File Number	PLSUP-2412-0029	Contact	Jason Mozol, jmozol@duluthmn.gov	
Type	Special Use Permit- Automobile Service	Planning Commission Date	May 13, 2025	
Deadline for Action	Application Date	April 16, 2025	60 Days	June 15, 2025
	Date Extension Letter Mailed	April 16, 2025	120 Days	August 14, 2025
Location of Subject	421 Anderson Rd			
Applicant	Take 5	Contact		
Agent	Sambatek	Contact	Joseph Bailey	
Legal Description	010-2589-00020			
Site Visit Date	April 21, 2025	Sign Notice Date	April 25, 2025	
Neighbor Letter Date	April 15, 2025	Number of Letters Sent	40

Applicant proposes to construct a 1,740 sq/ft oil change business.

Recommended Action: Approve with conditions.

SHEET
L1.01
 12 OF 13
 REV.

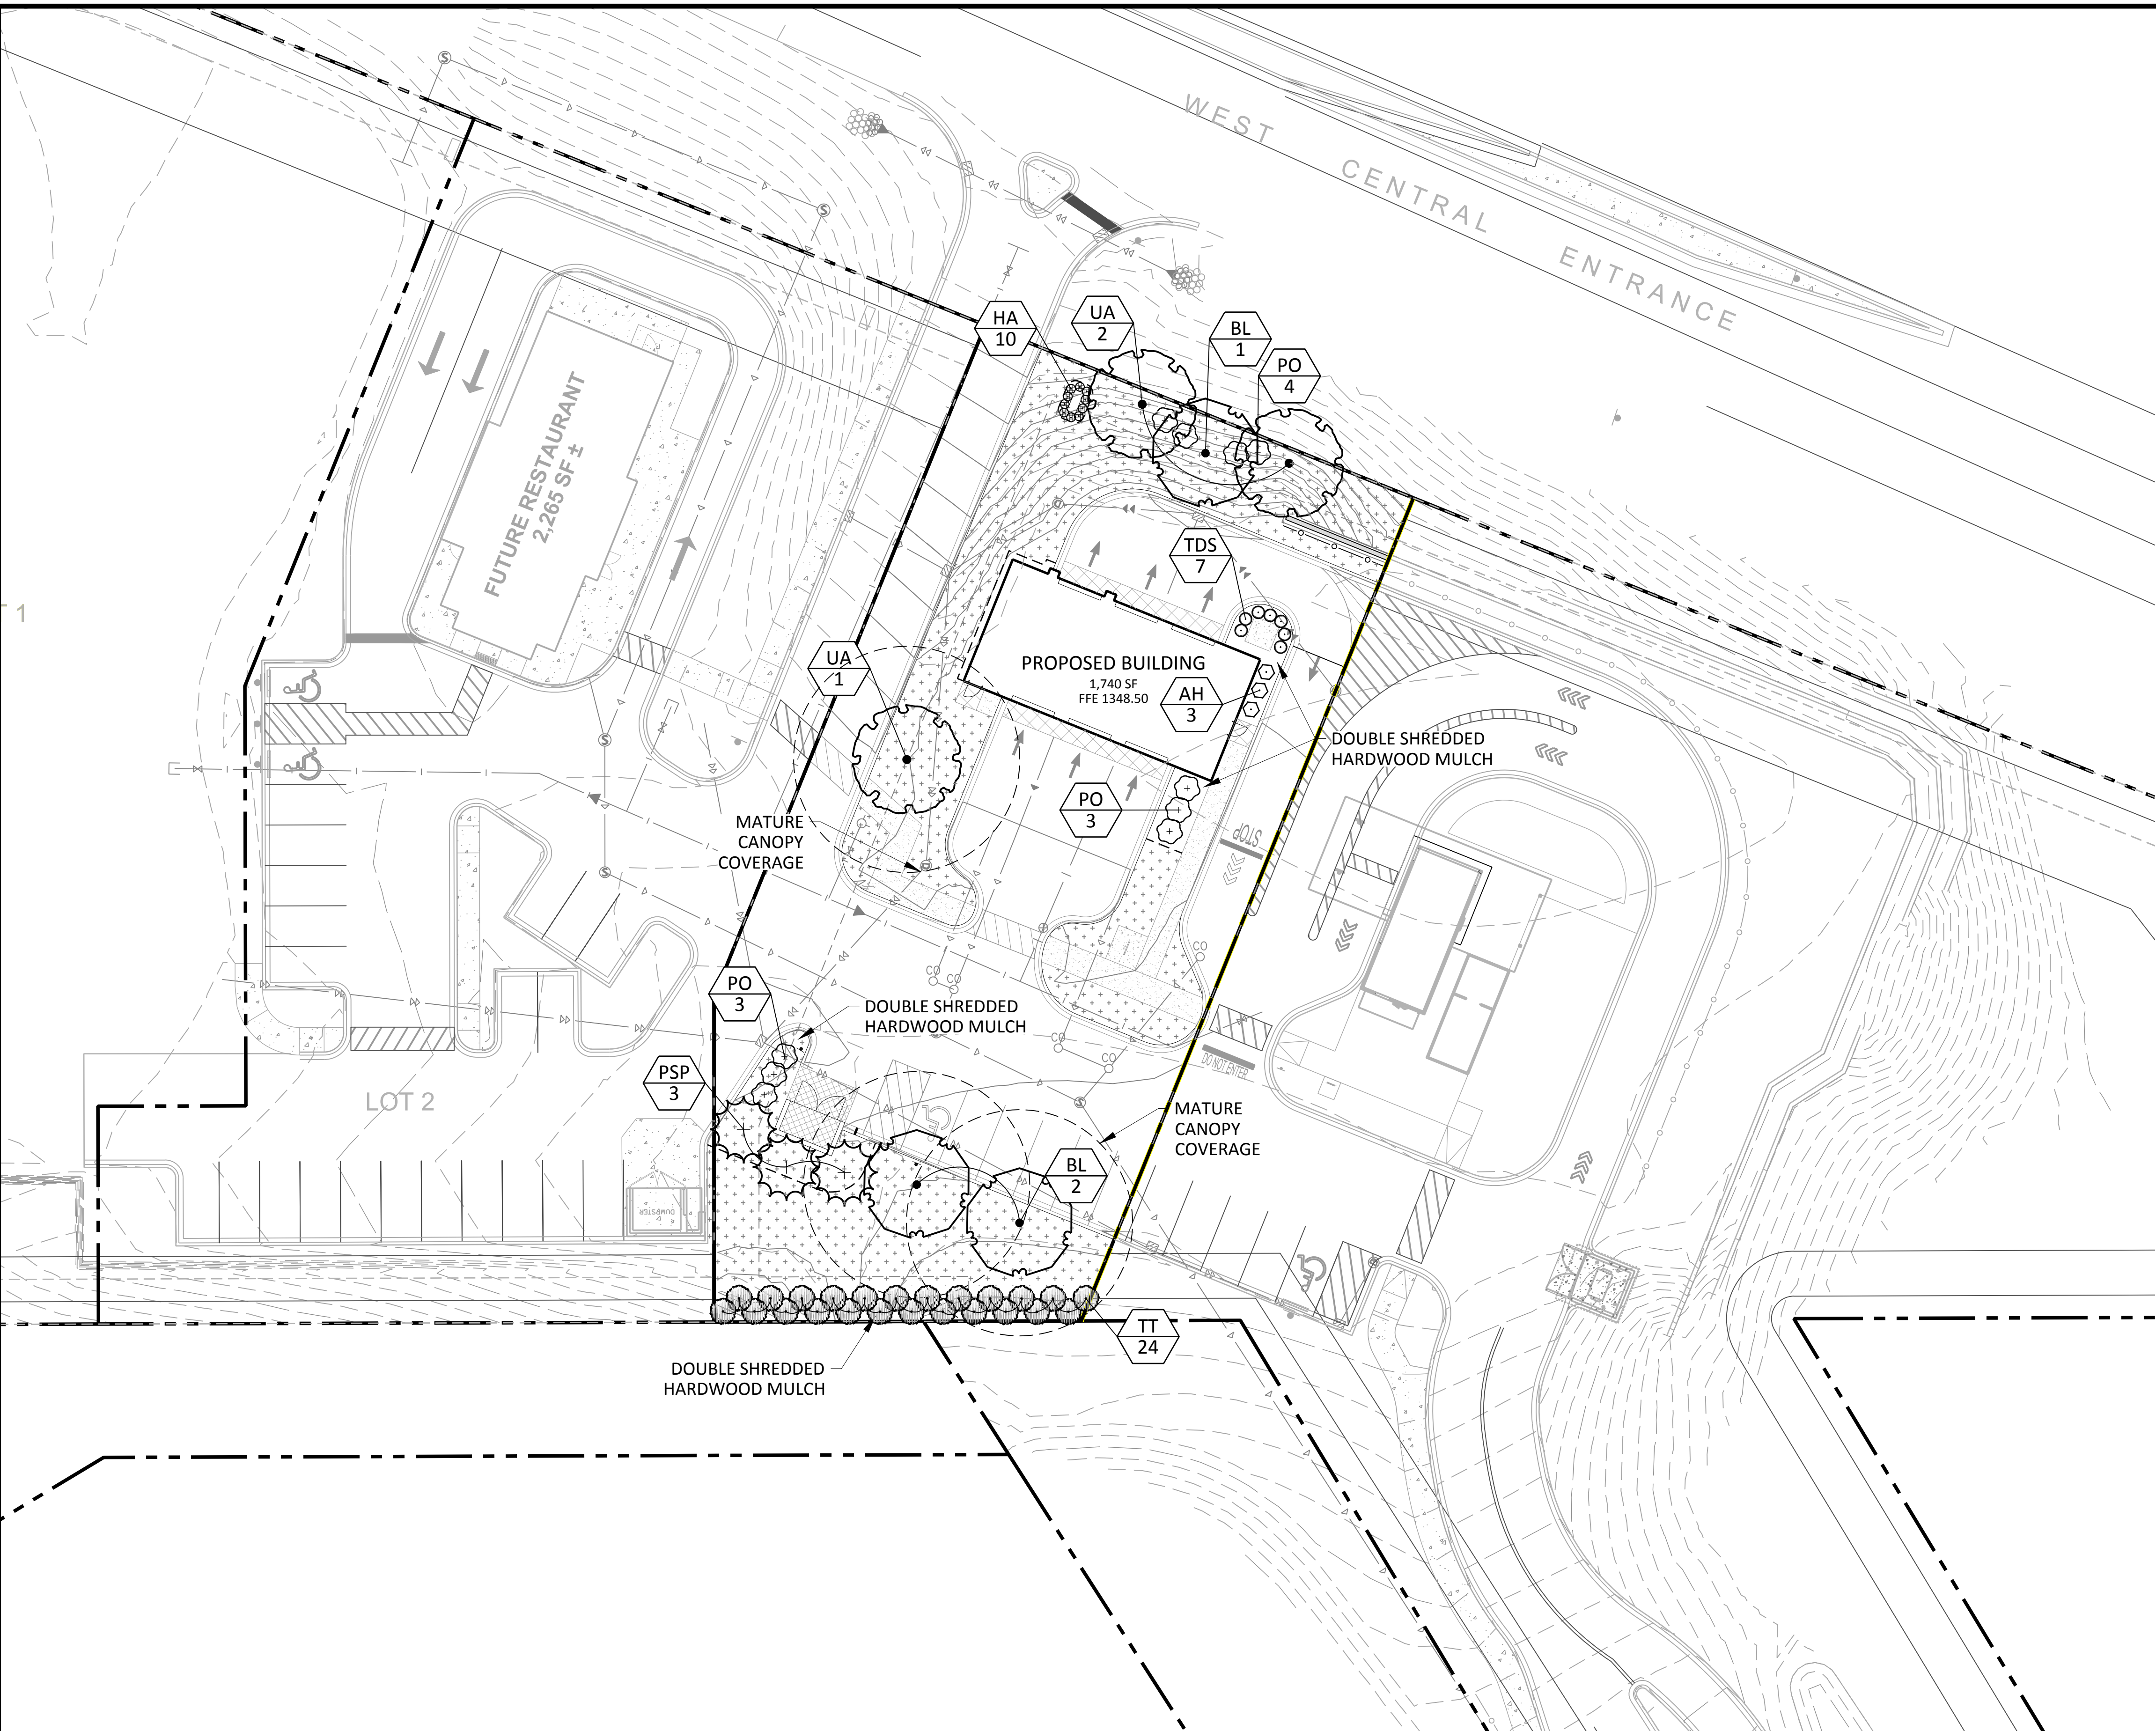
2. UDC Sec. 50-20.3.C (Use-specific Standards).
 - a. The rear property line will be screened by a vegetation and required fencing meeting the standard of a dense urban screen. Side property lines do not need to be screened since this is part of a single, coordinated development in one plat by a single developer intended to operate as one unit with vehicle and pedestrian traffic moving freely between sites.

5. During a recent site visit, staff noted that the site has been poorly managed, (see attached photos), and resulted in trash blowing into the neighbor's yard and gaps where all native vegetation has been cleared. To adequately reduce negative impacts to neighboring properties, staff recommends that a 6' tall, opaque fence is built along the rear of the property in addition to the proposed vegetative screening.

1. The project, as modified by the conditions summarized below, be limited, constructed, and maintained consistent with plans submitted with the application.
2. The auto service use may operate between 7am and 8pm.
3. In addition to the proposed vegetative screening, 6' tall, opaque fencing must be installed along the rear of the site.
4. Final, compliant exterior lighting and landscaping plans must be submitted to and approved by the Land Use Supervisor prior to a building permit being issued.
5. Any alterations to the approved plans that do not alter major elements of the plan may be approved by the Land Use Supervisor without further Planning Commission; however, no such administration approval shall constitute a variance from the provisions of Chapter 50.

LIGHTING PROPOSAL LO-161771-1			
TAKE 5	DULUTH, MN		
BY/OK	DATE/1/13/25	REV/2/18/25	SHEET 1 OF 1
SCALE: 1"=16'		0	16

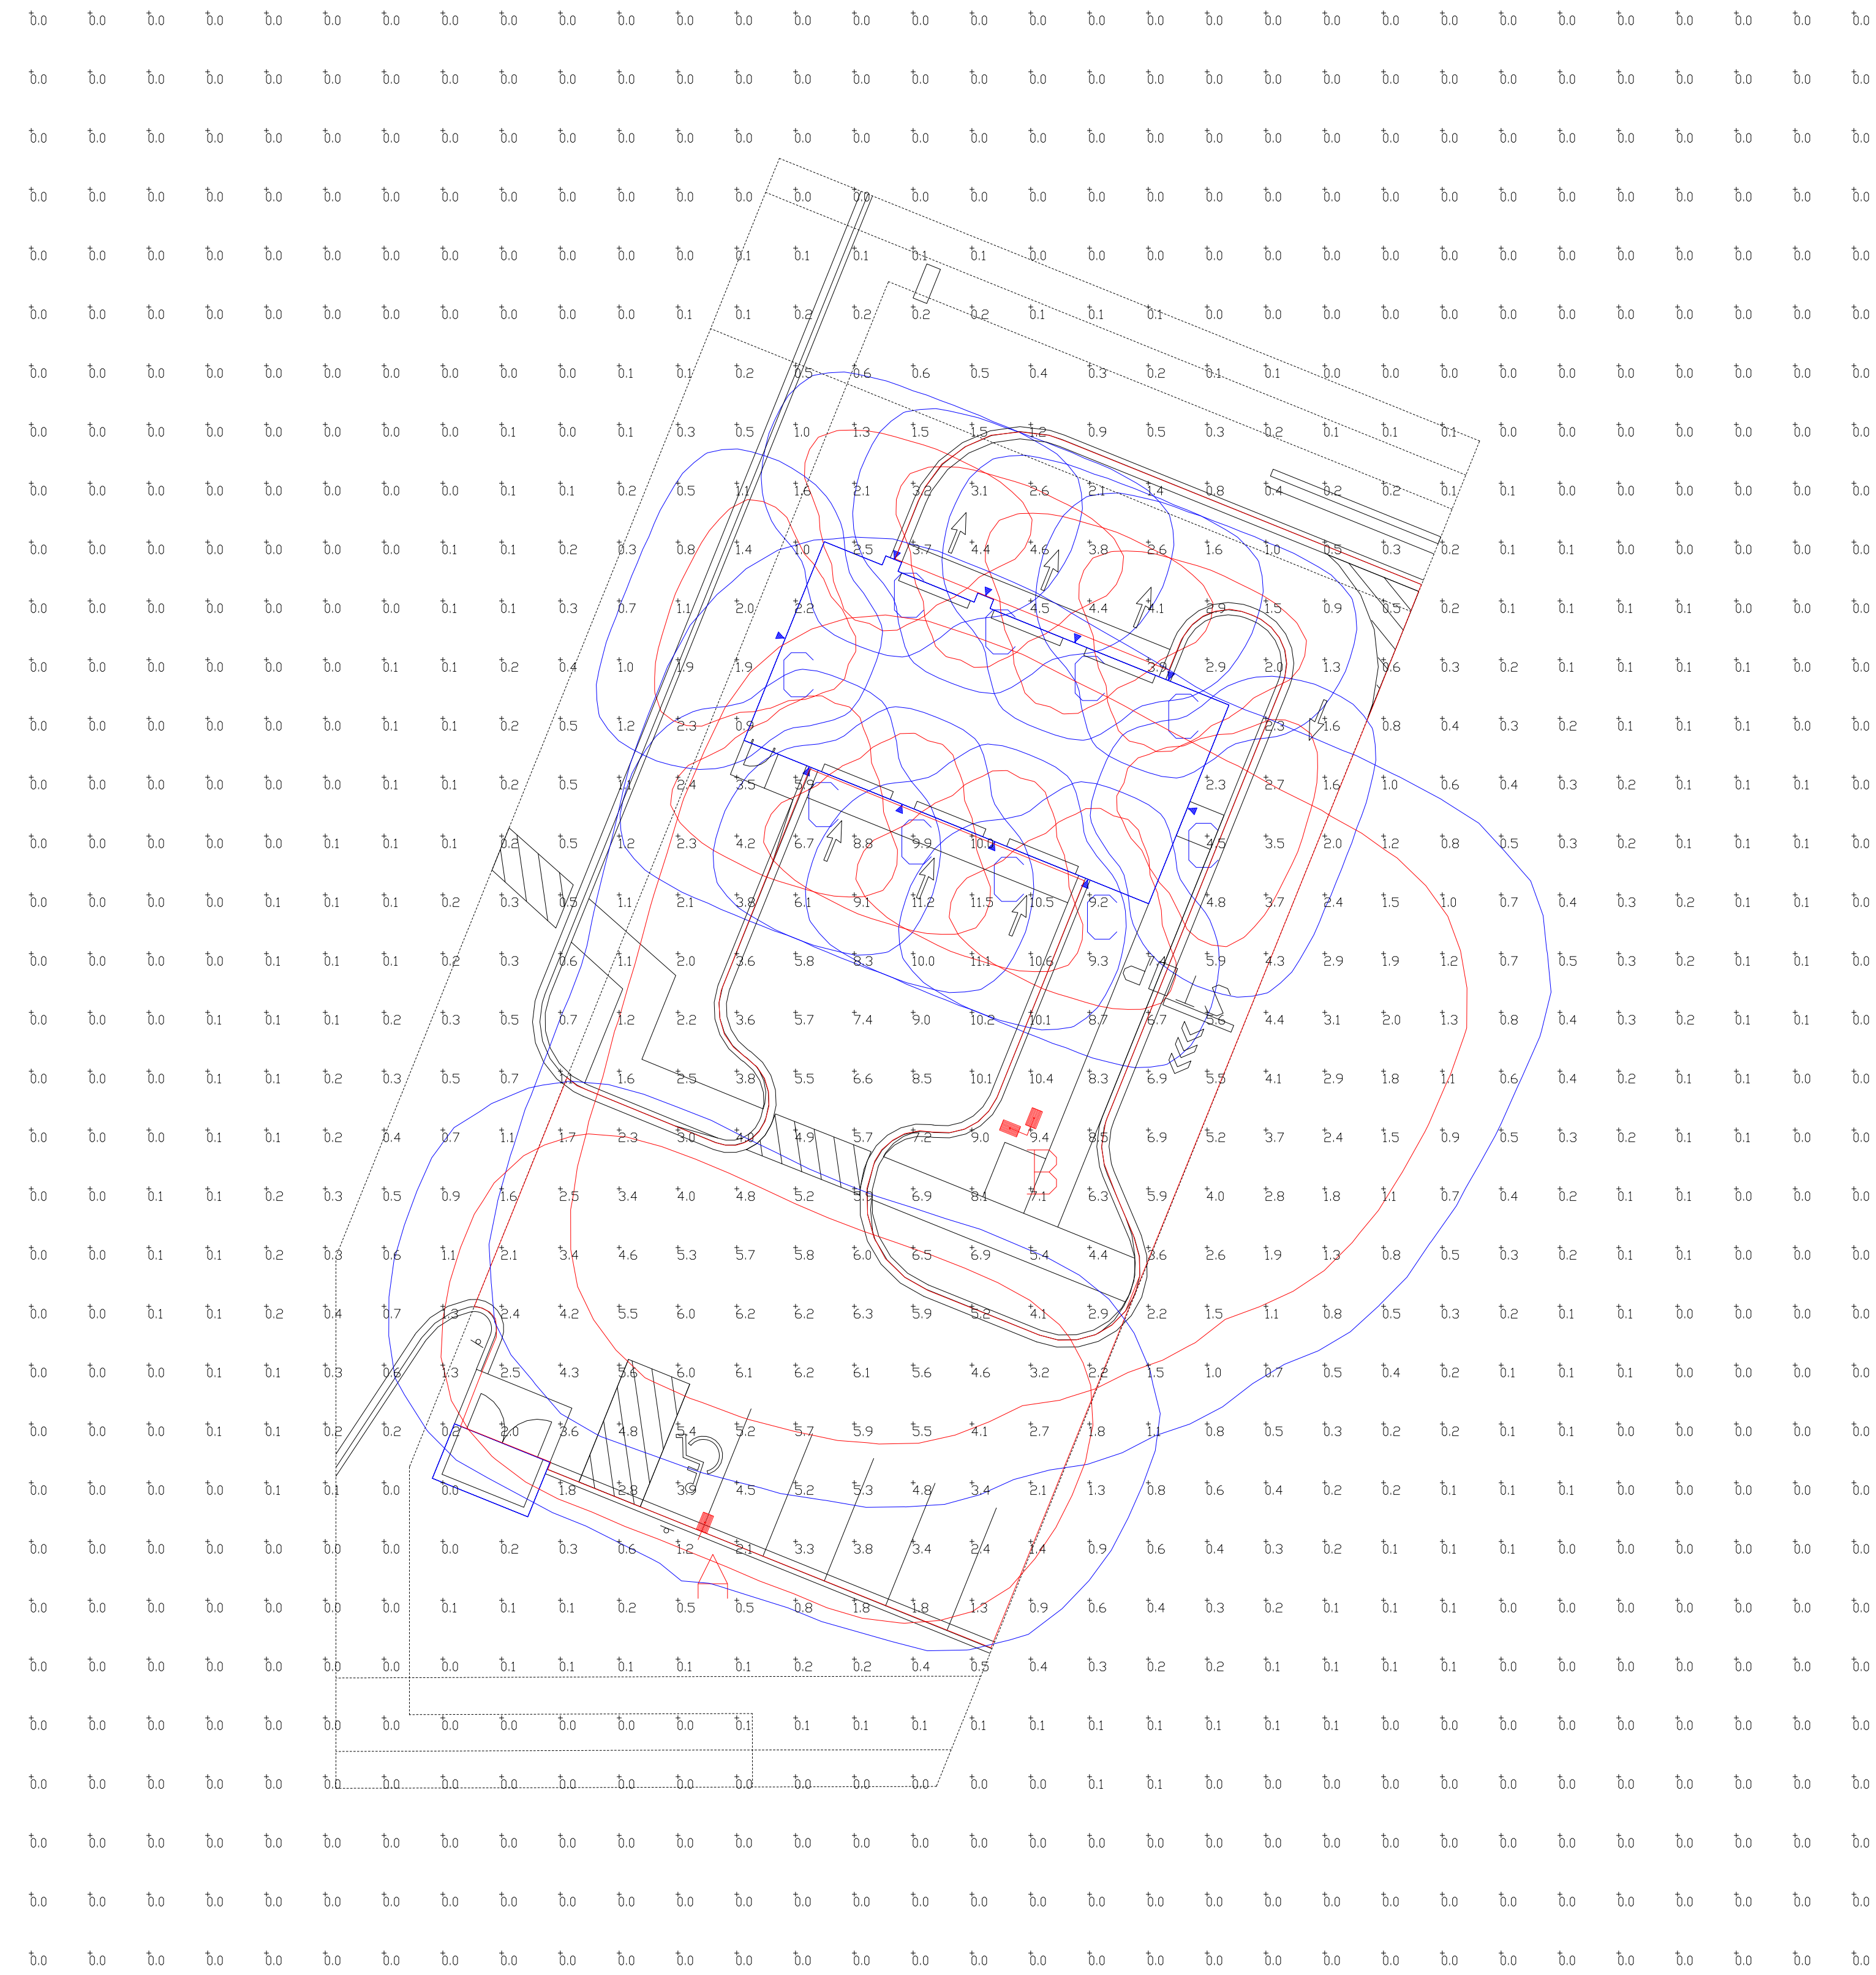
8. UDC Sec. 50-31 (Exterior Lighting). The applicant has submitted a photometric plan with light fixtures that are not fully code compliant. Lighting to the rear of the building exceeds the allowable maximum levels. A compliant photometric plan with light fixtures must be submitted to the Land Use Supervisor prior to building permit issuance.
